Co3072 – Jericho BF 0209(10)

ADDENDUM #1

REVISED: Plan Sheets 2, 5, 7, 23, 24, and 40 and Invitation for Bids.

FILE NAME: sl2j634sup.dgn
PROJECT LEADER: R. YOUNG
DESIGNED BY: A. MANN
SOLID SLAB PLAN & ELEVATION DETAILS

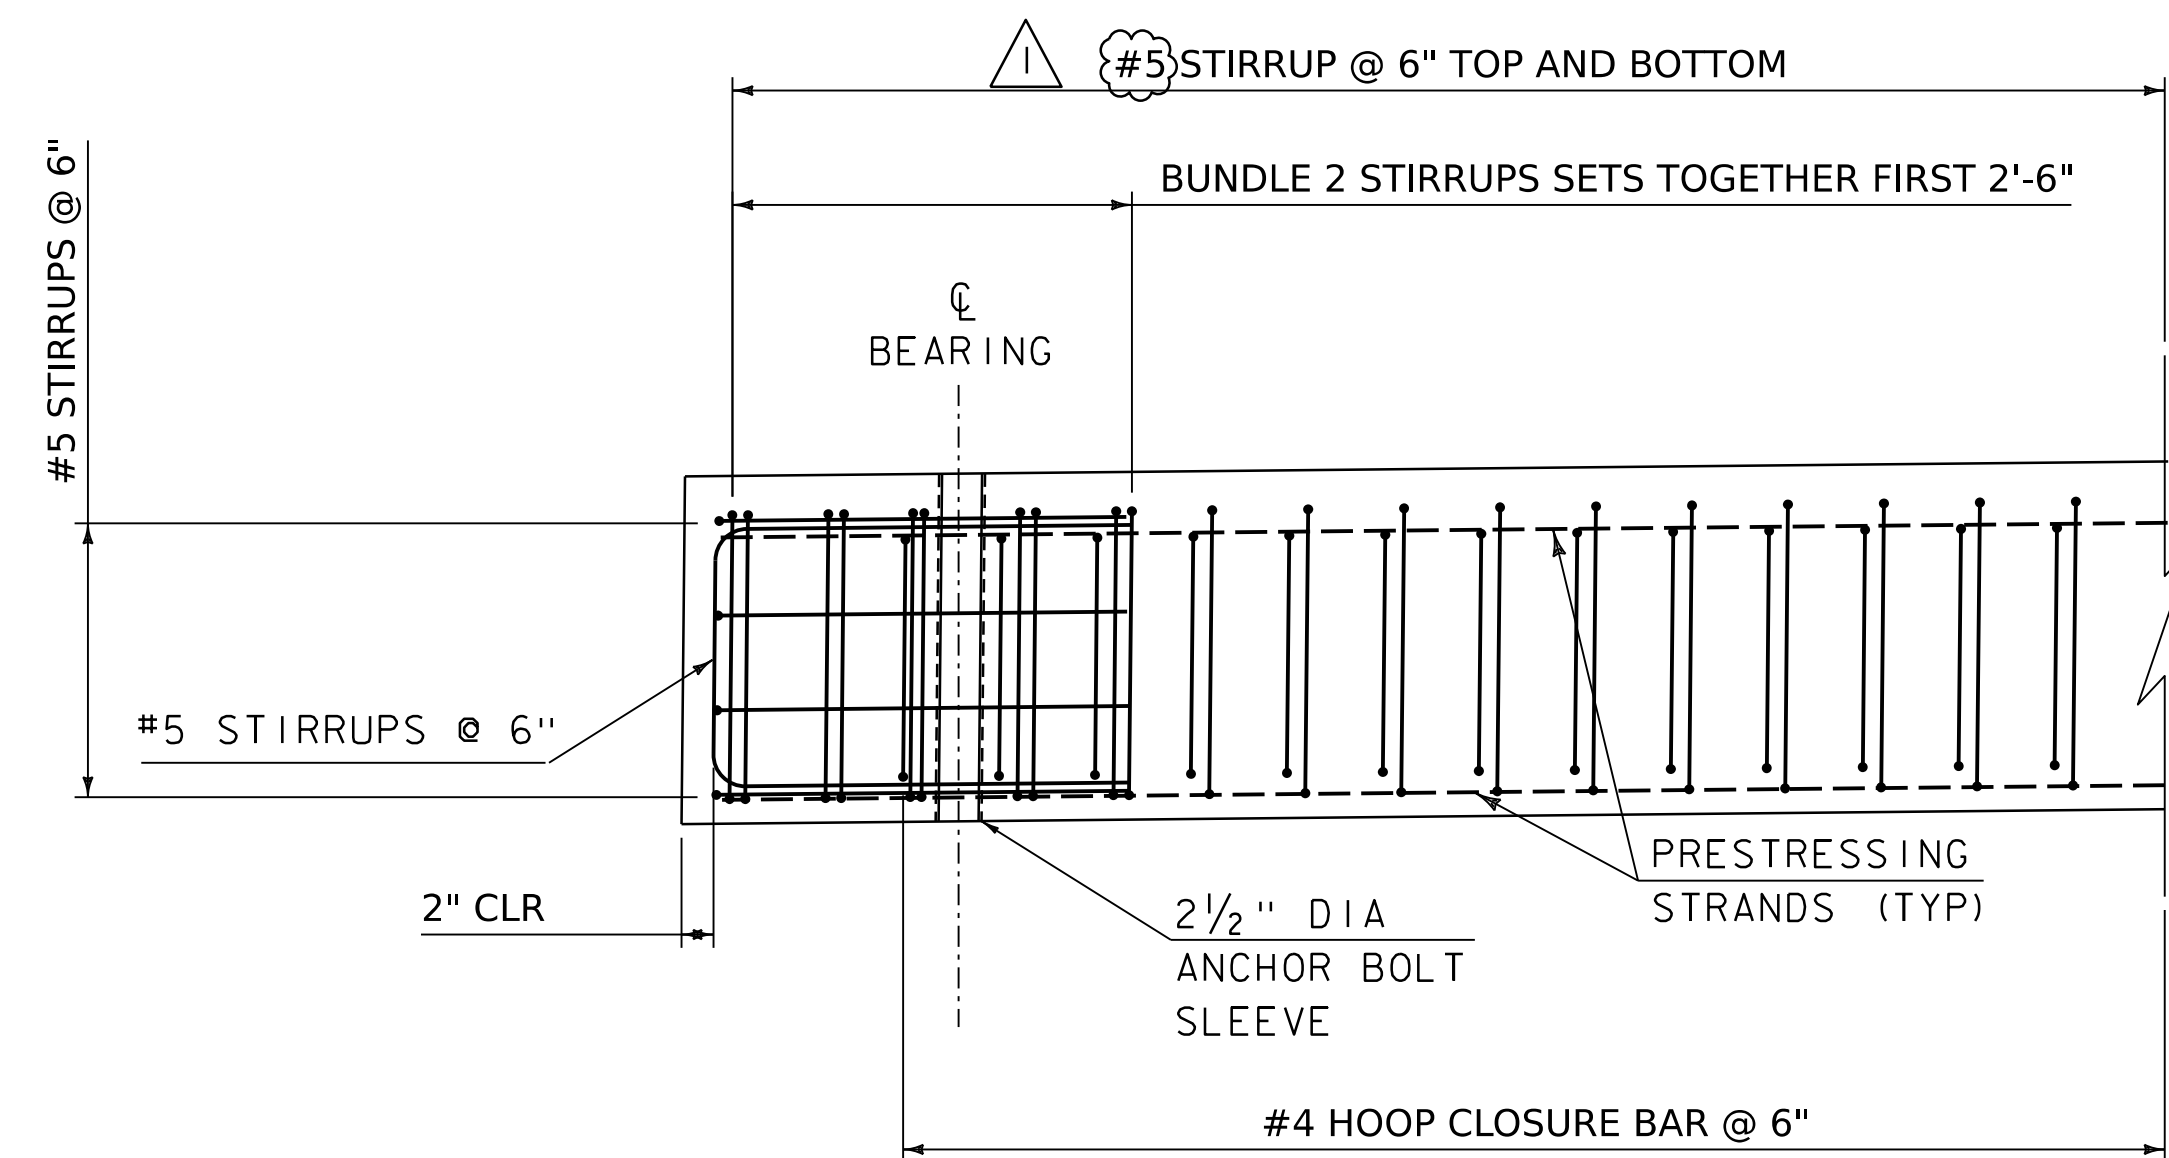
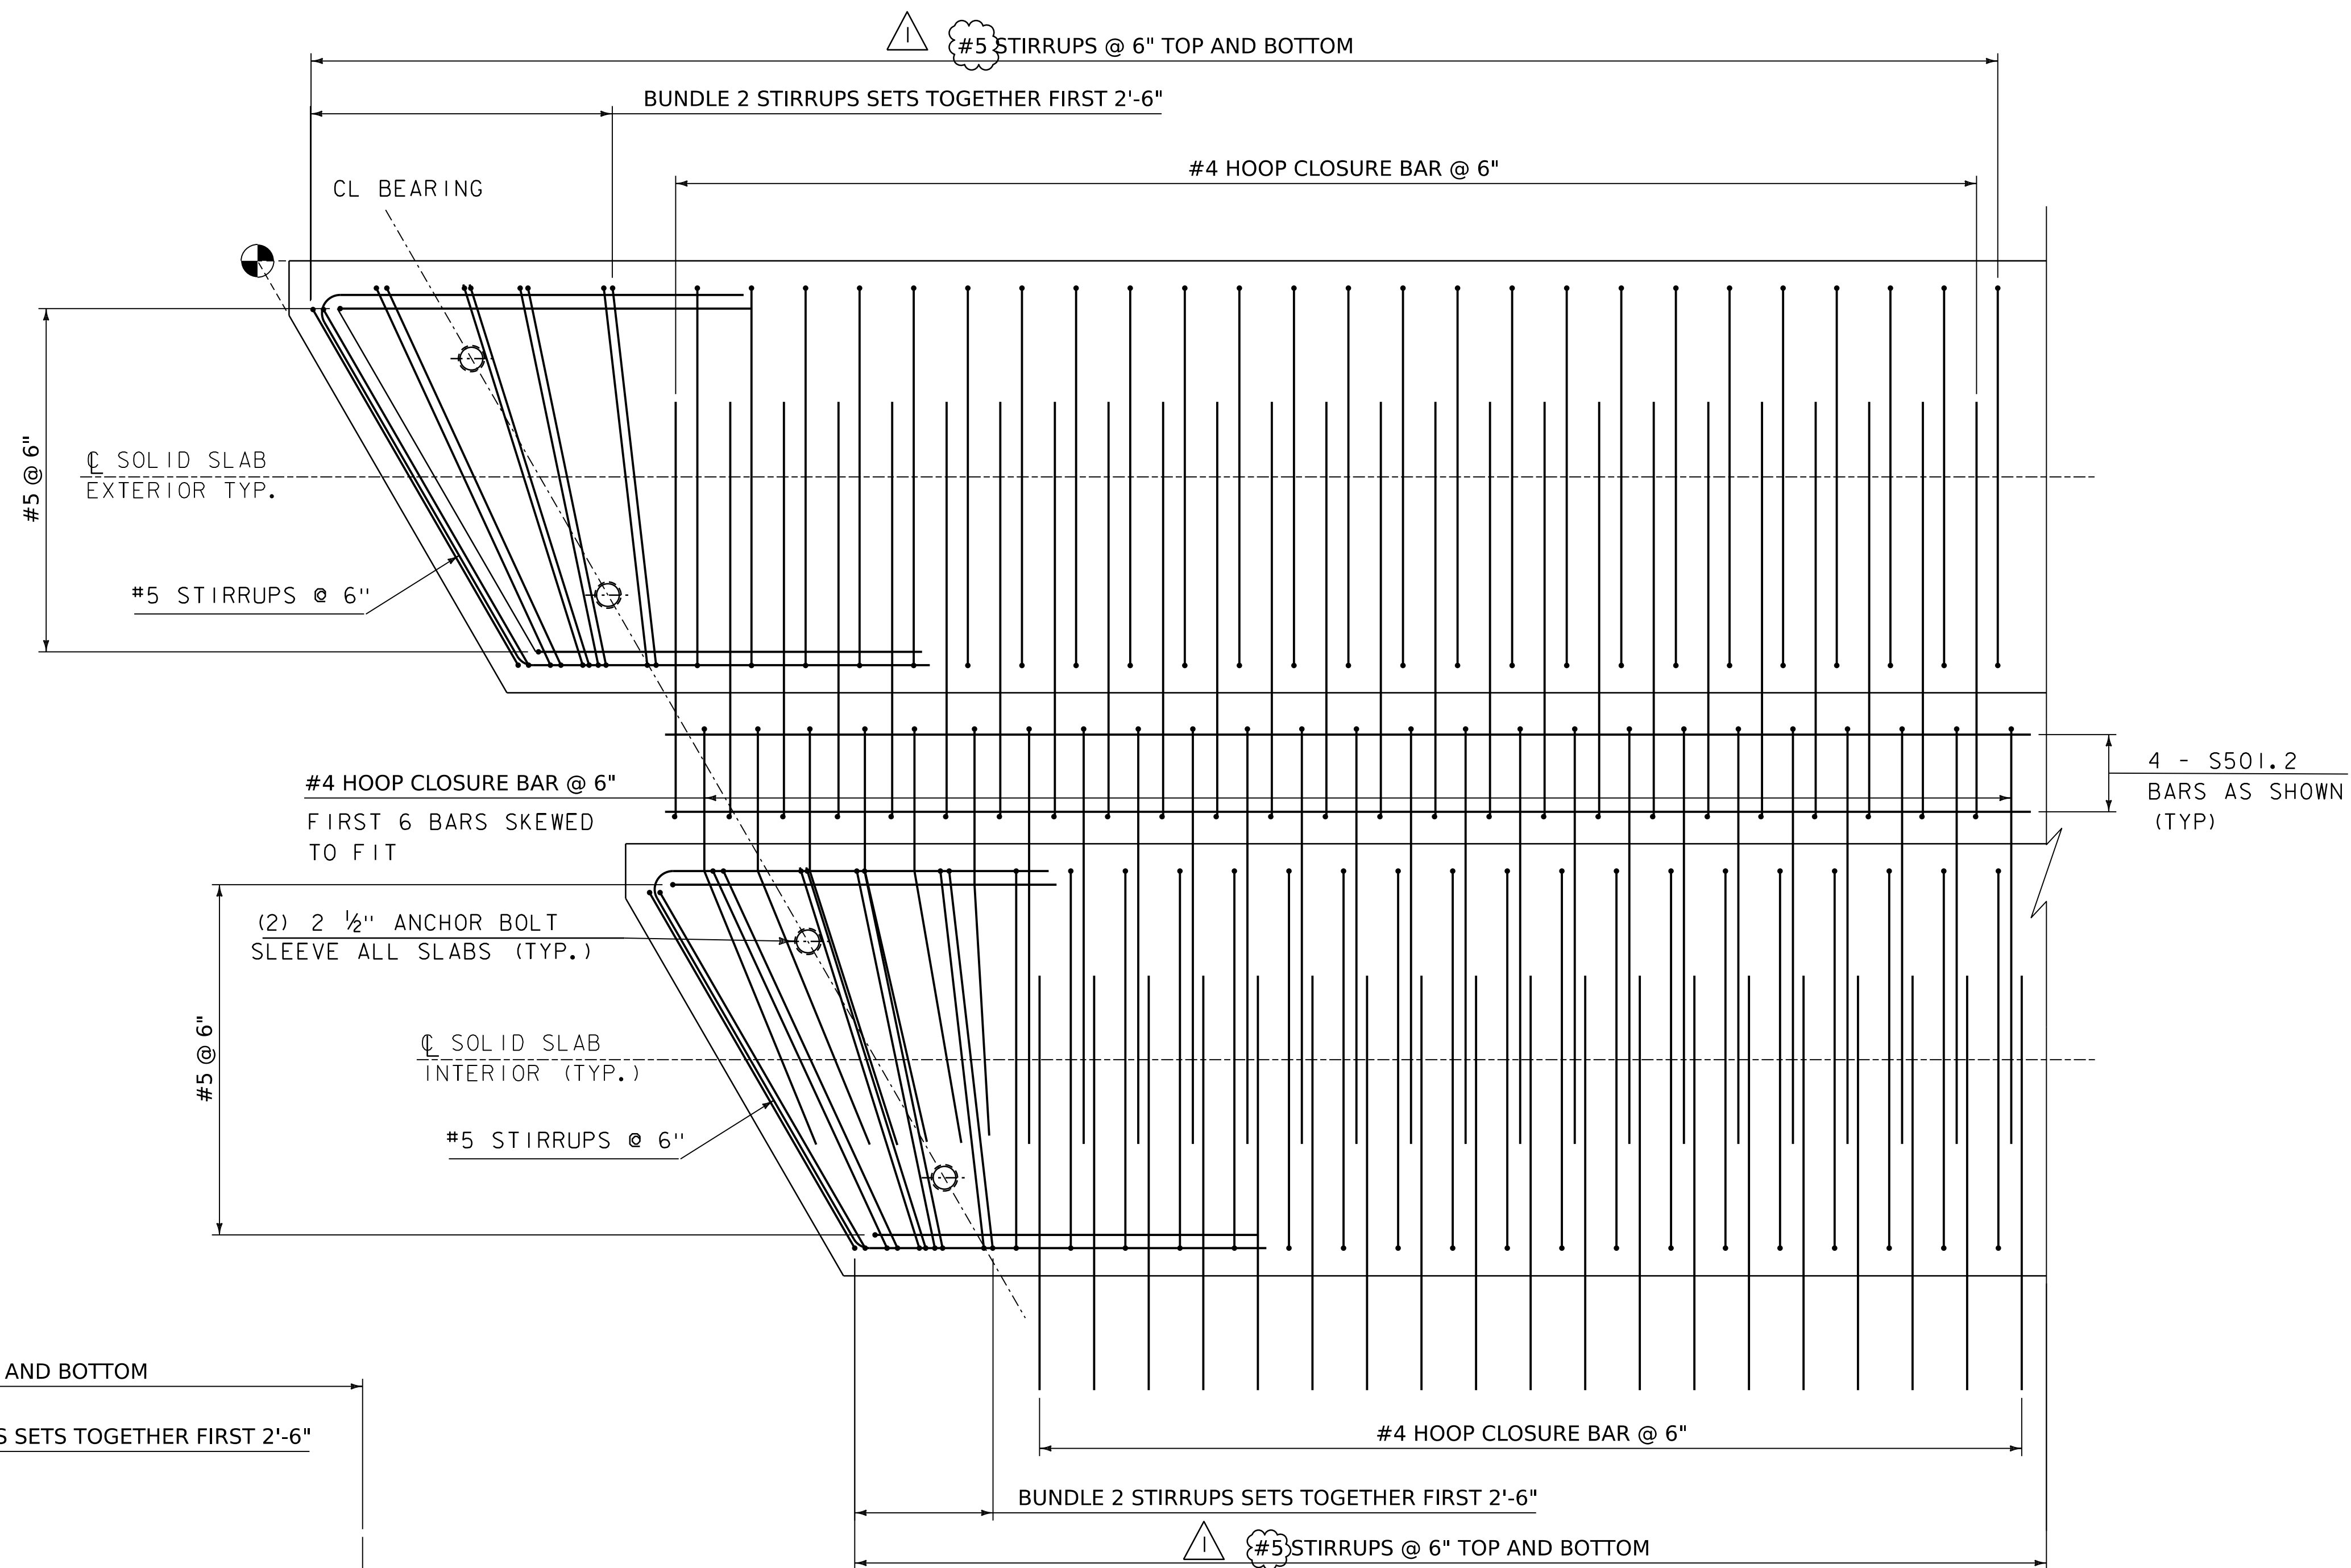
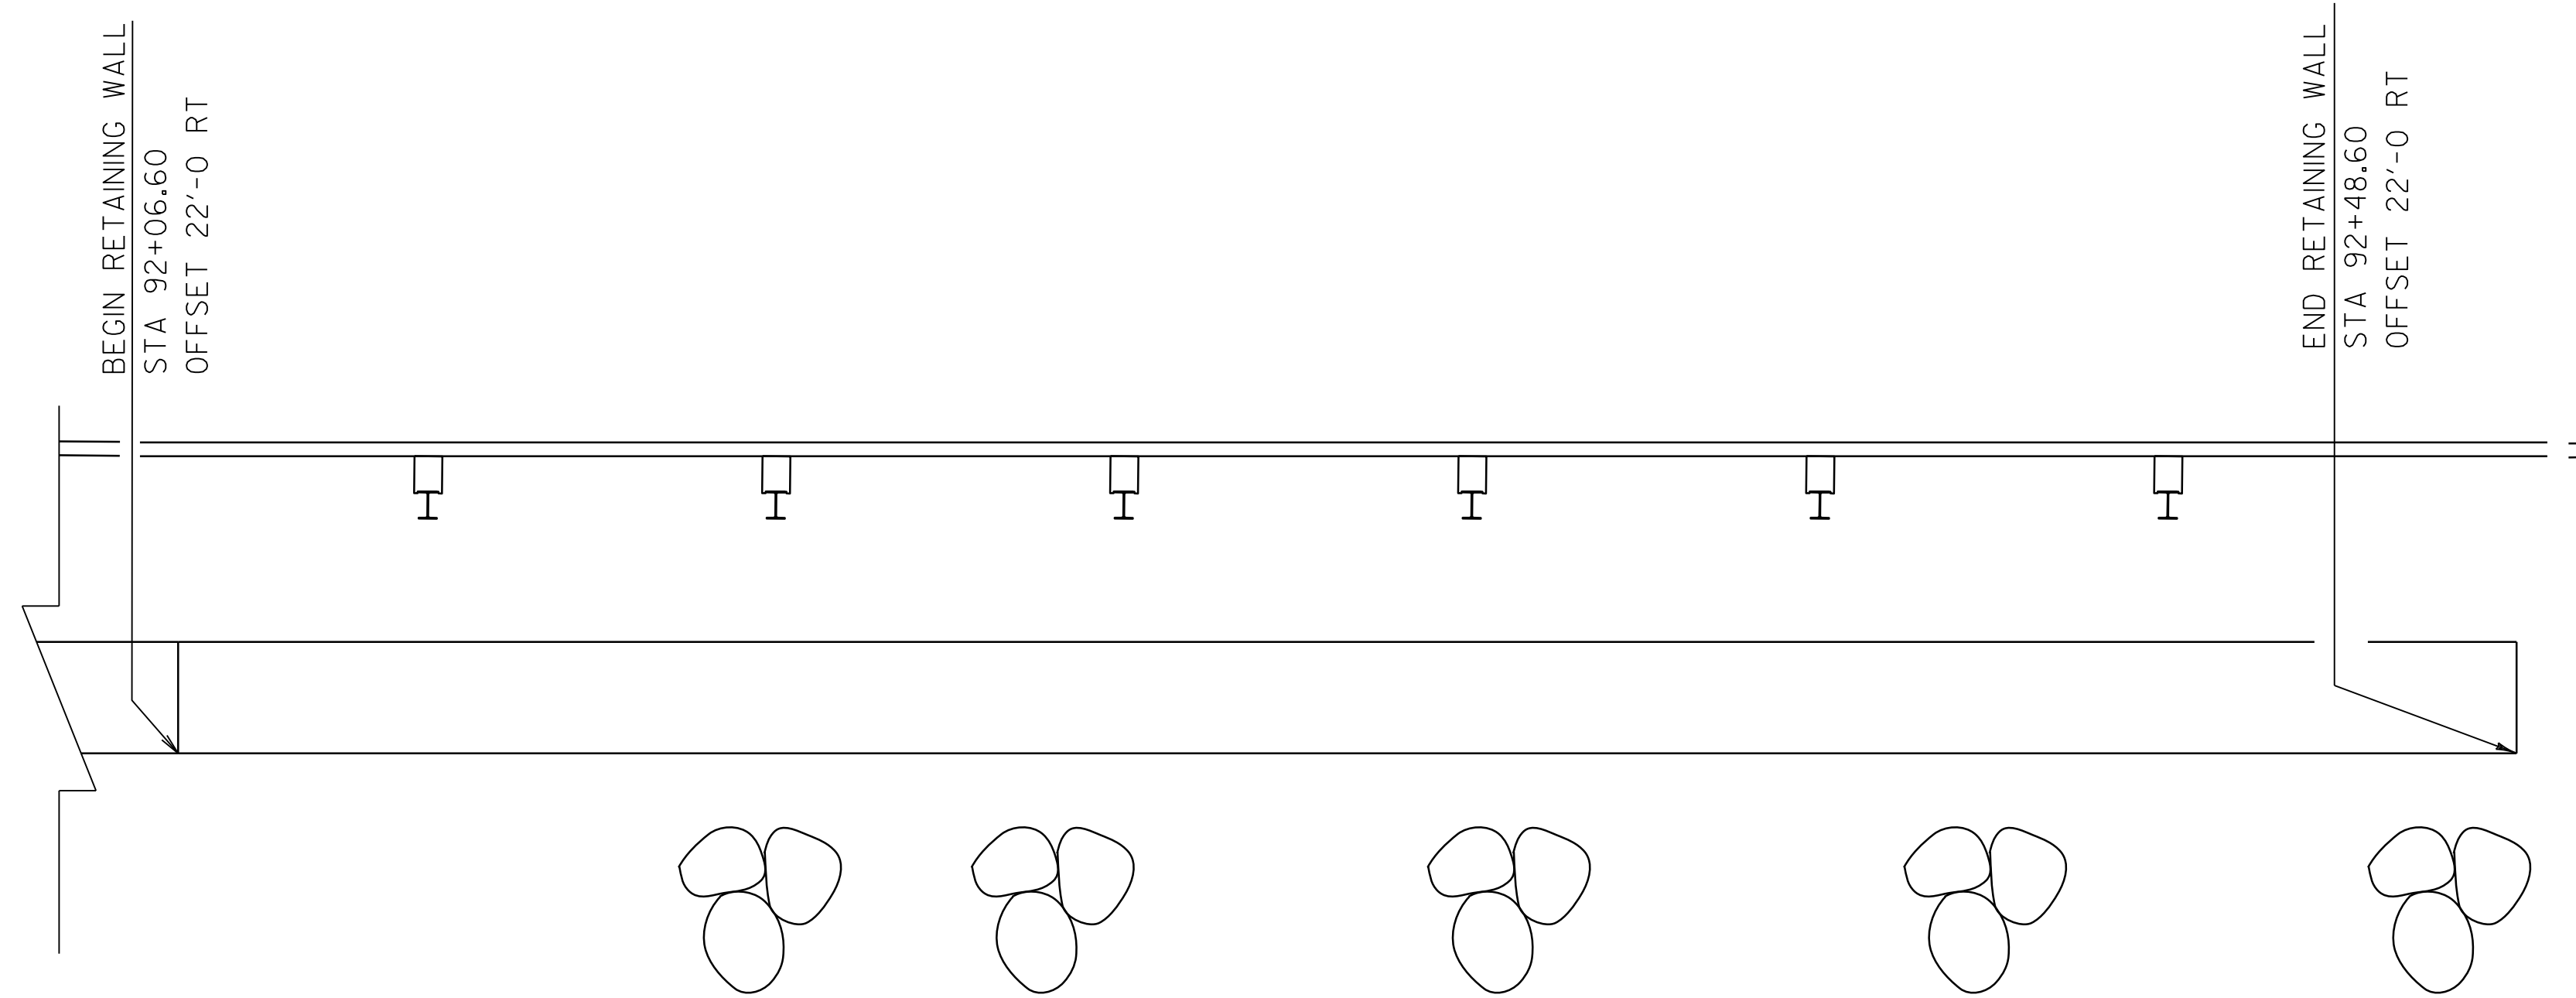
ADDENDUM	REVISION	DATE	BY	DESCRIPTION
△	I	11/05/2024	VAOT	STIRRUP SIZE
